Revision 4 October 2019

# Customer Satisfaction Notification V41

## Steering Damper

**NOTE: New information for Step 9 and 10.**

Figure 1 – Steering Damper

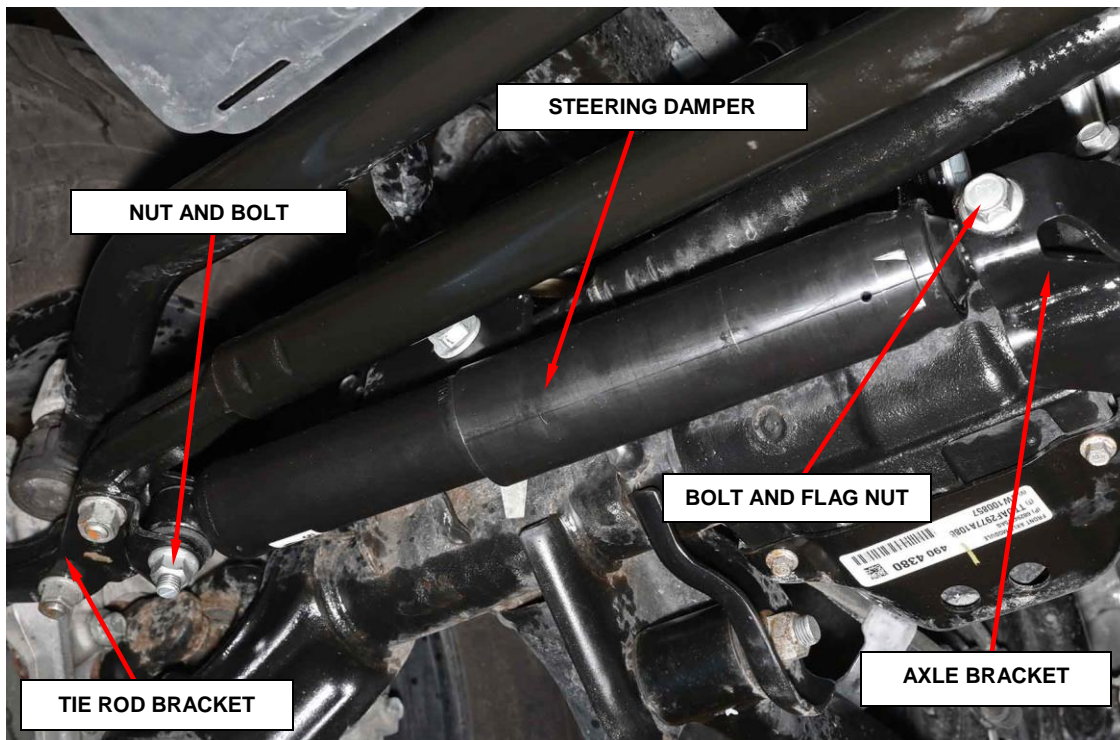
9. Tighten the **NEW** steering damper **bolt** on the axle bracket to 80 N·m (59 ft. lbs.) (Figure 1).
10. Tighten the **NEW** steering damper nut on the tie rod bracket to **80** N·m (**59 ft.** lbs.) (Figure 3).
11. Lower the vehicle and return it to the customer.
